Access Compliance Report

Public Rights-of-Way

| Intersection ID: 10040201 | Main Street: TYVOLA_RD | Cross Street: N/A | Location: SE |
| ADA ID: 055CCA79D7C2 | Ramp Type: Directional1 | Initial Pass/Fail: Fail | Overall Compliance: No |

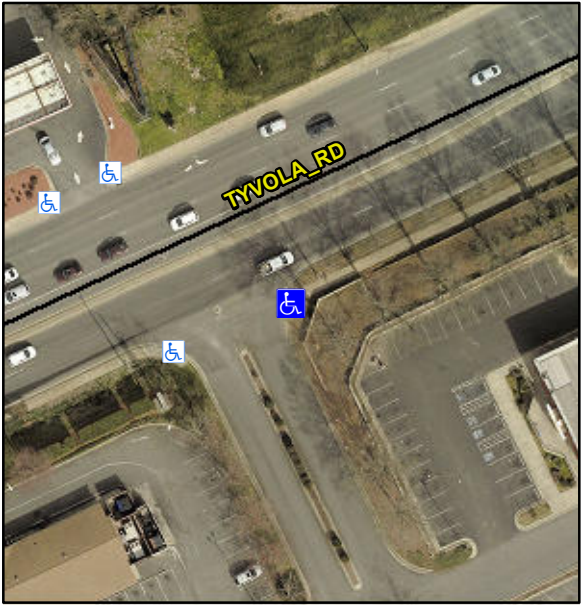
| | | No | Ramp XSlope (%) | 5.0 | | | |
| | PROW/ADA: R304.5.3 | N/A | Landing Slope (%) | 0.0 | N/A | DWS Length (in) | N/A |

| | Remove & Replace Entire Ramp. | | | | | | |
